W D R SUBDIVISION

The preliminary plat illustrates the proposed 2-lot, 19.3± acres subdivision located at the West Side of Dykes Road North, 9/10± mile South of Tanner Williams Road West, within the Planning Jurisdiction. The applicant states the site is served by public water and individual septic systems. The purpose of this application is to create two (2) legal lots of record from one (1) metes-and-bounds parcel.

DETAIL SITE PLAN

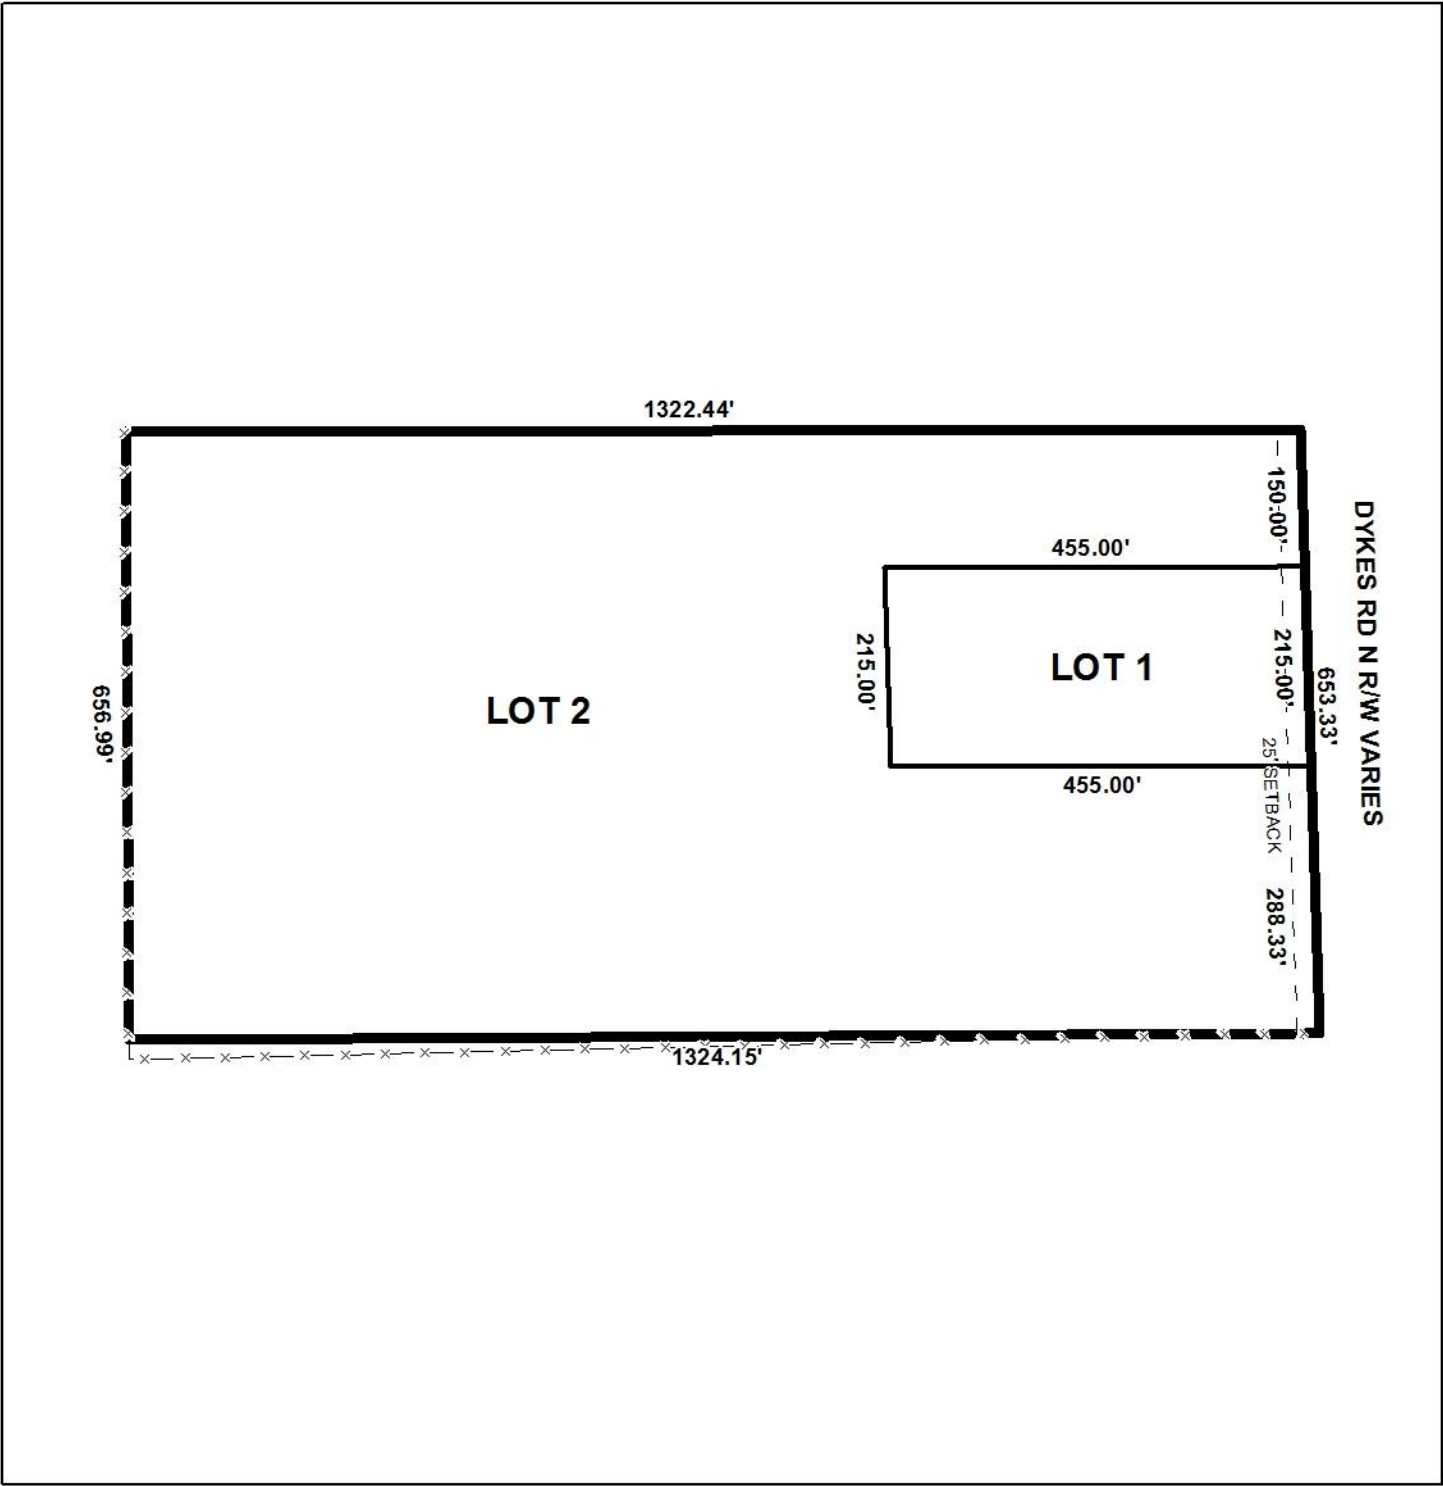
The proposed lots have frontage along Dykes Road North, a minor street without curb and gutter requiring a 60' right-of-way. A minimum right-of-way of 65' is illustrated on the preliminary plat and should be retained on the Final Plat, if approved.

Proposed Lot 2 is irregularly shaped with Lot 1 proposed to be subdivided from the center of the Lot 2's frontage, thus creating a situation in which Lot 2 will have interrupted street frontage. No justification for the design was provided to staff, but the applicant states that their son wishes to build a house on proposed Lot 1, on which there appears to be located a mobile home. Such a lot design is not common within the vicinity of the subject site with the exception of 767, 801, 1301, and 1321 Dykes Road North; however, these locations are metes-and-bounds parcels and not legal lots approved by the Planning Commission. As such, precedence for legal lots similar to the proposed design of the subject site has not been established, but similar designs for metes-and-bounds parcels may nevertheless reflect the design standard of the neighborhood. A waiver of Section V.D.1. of the Subdivision Regulations would be required for approval.

It should be noted that the widths of the portions of Lot 2 along which it has split street frontage are large enough to be potentially re-subdivided and, in accordance with Section V.D.3. of the Subdivision Regulations, is not exclusive of unusable land thus contributing to maximum depths more than 3.5 times their widths at their potential building lines. Revision to the design of the lot may resolve this issue, but if approved, as proposed, a waiver of Section V.D.3. will be required.

Both lots meet the minimum size requirements for lots served by public water and individual septic systems and are appropriately labelled in square feet and acres. This information should be retained on the Final Plat, if approved; or, provision of a table on the Final Plat providing the same information may suffice.

The 25' minimum building setback line is labeled along the frontages of both lots and should be retained on the Final Plat, if approved.

As a means of access management, a note should be placed on the Final Plat stating that Lots 1 and 2 are limited to a maximum of two (2) curb cuts each to Dykes Road North, with any changes in their sizes, locations, or designs to be approved by Mobile County Engineering and conform to AASHTO standards.

- 1) retention of a minimum 60' right-of-way along Dykes Road North;
- 2) retention of the lot sizes in square feet and acres on the Final Plat, or provision of a table providing the same information;

- 3) retention of the 25' minimum building setback line along Dykes Road North;
- 4) placement of a note on the Final Plat stating Lots 1 and 2 are limited to two (2) curb cuts each to Dykes Road North, with any changes in their sizes, locations, or designs to be approved by Mobile County Engineering and conform to AASHTO standards;
